Service bulletin

C. 207

THE BRITISH MOTOR CORPORATION (AUSTRALIA) PTY. LIMITED

ACCELERATOR PEDAL BENDING.

Hinge Joint of Pedal
showing hard corner

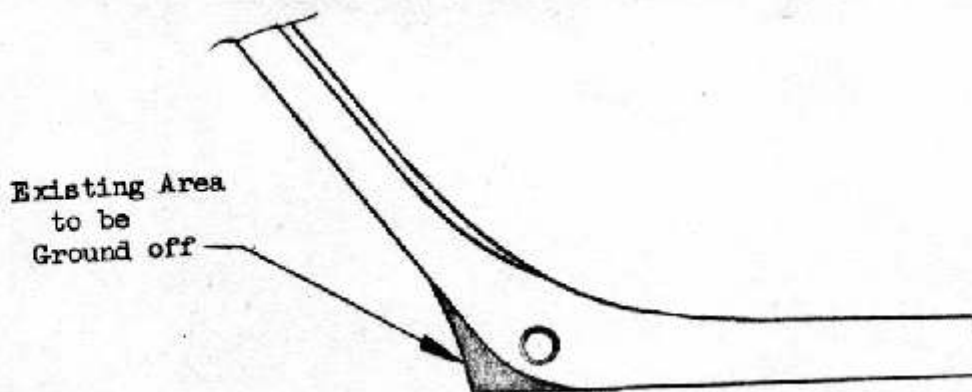
To prevent the Pedal from bending at hinge joint and also from bowing through the length when fully depressed - due to a hard corner of rubber under pivot point - a service modification is to grind away the hard corner and if sheet metal holding screw cannot be kept in position they should be replaced with machine screws, nuts and washers.

This modification has now been carried out in Production.
